MCW Consultants Ltd.

Addendum

Project Name: AQUAVISTA - Bayside
Client: TRIDEL Corporation
To: TRIDEL Corporation
Attention: Chadi Loza
Fax number: -

Title: Various Electrical Changes.

NOTE: PROVIDE 3 WIRE ON THE LOAD SIDE OF THE STARTER

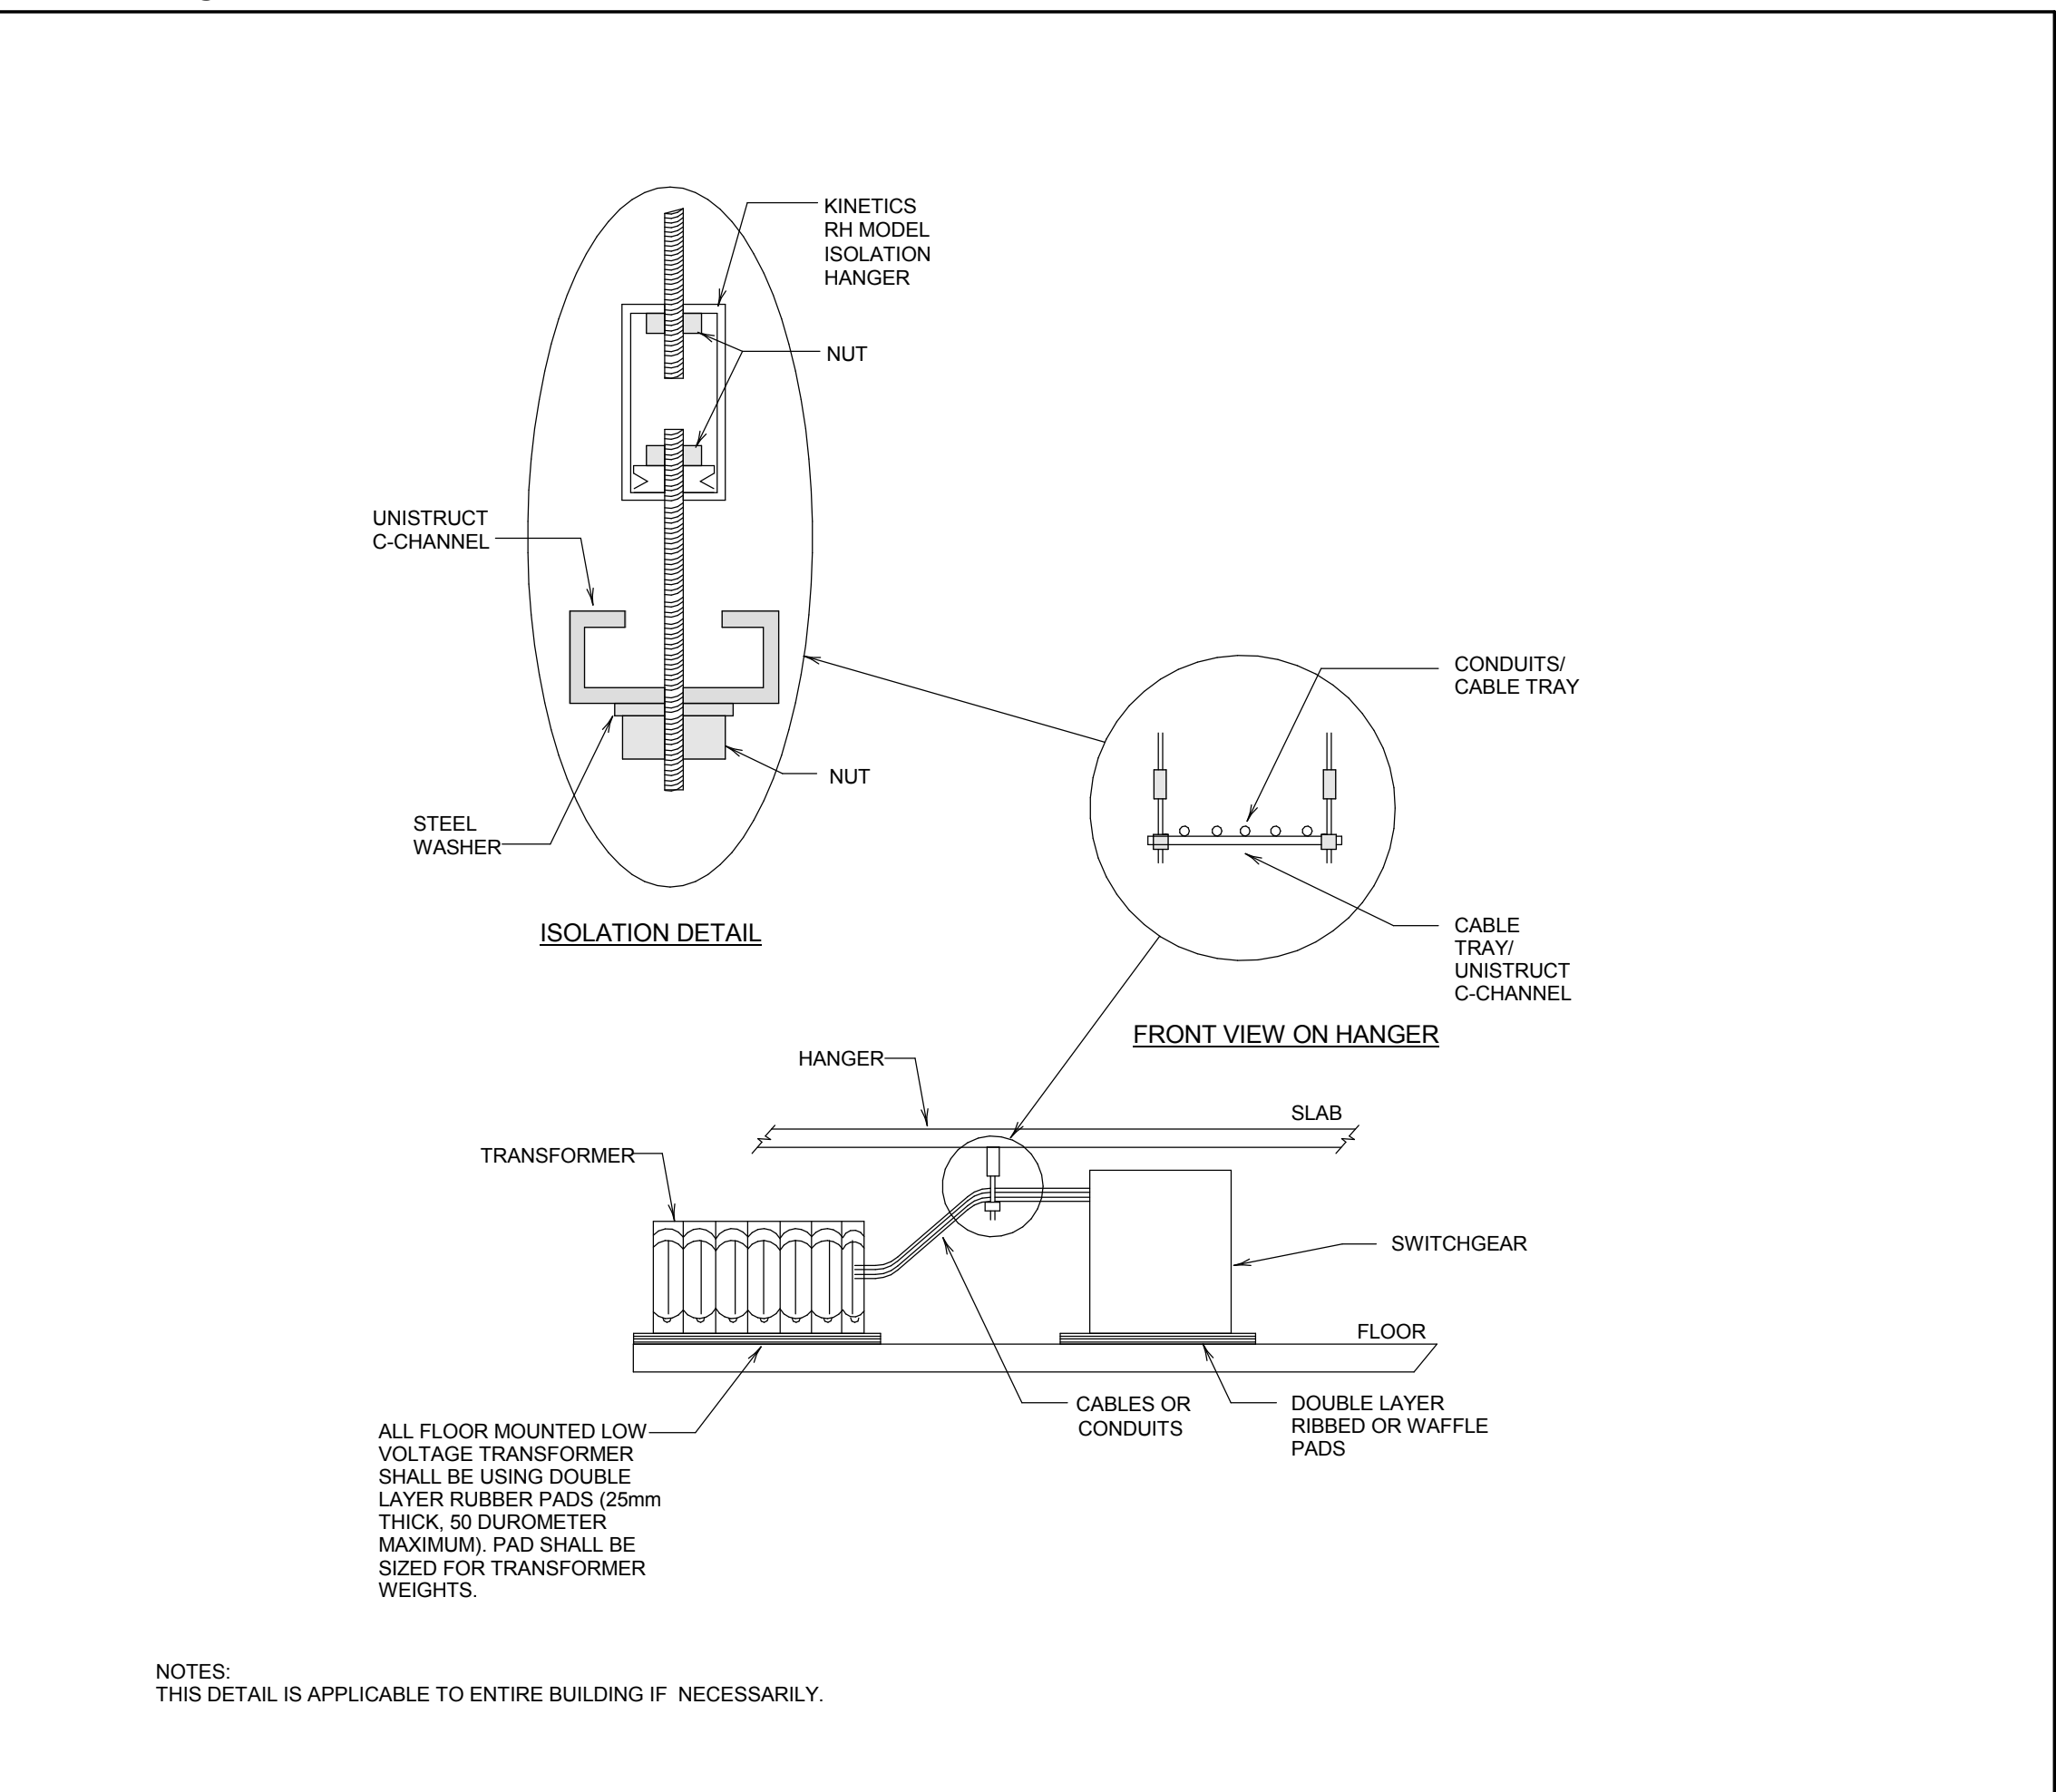
Drawing No.	Drawing Issued	Items
ME-15	Yes	Update ME schedule as shown. Contractor to coordinate with mechanical drawings for the exact location of the units.
